Service Bulletin

Bulletin No.: PI0986

Subject: Rattle Noise from Engine Compartment

Models: 2012-2013 Buick Enclave
2012-2013 Chevrolet Traverse
2012-2013 GMC Acadia
Built Prior to April 11, 2013

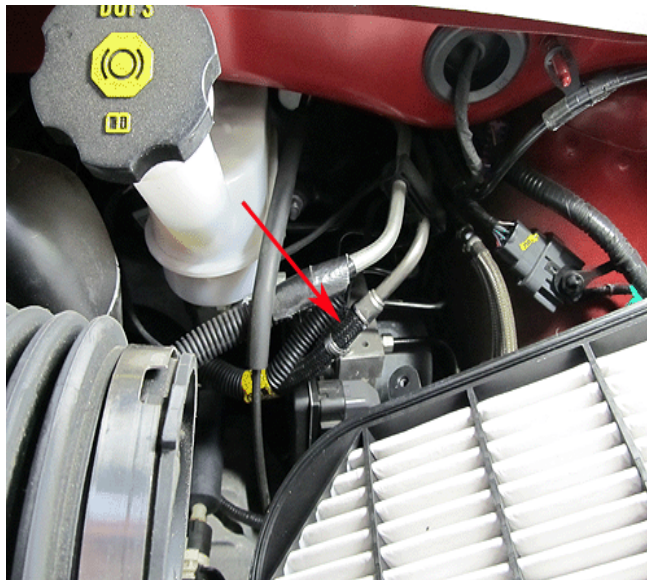
Some customers may comment on a rattle noise coming from the engine compartment, most noticeable between the 600-800 RPM range.

The check valve in the fuel line may not have been properly crimped in the line and may create a rattle. The crimped clamp often can be turned on the hose if the clamp has not properly captured on the check valve.
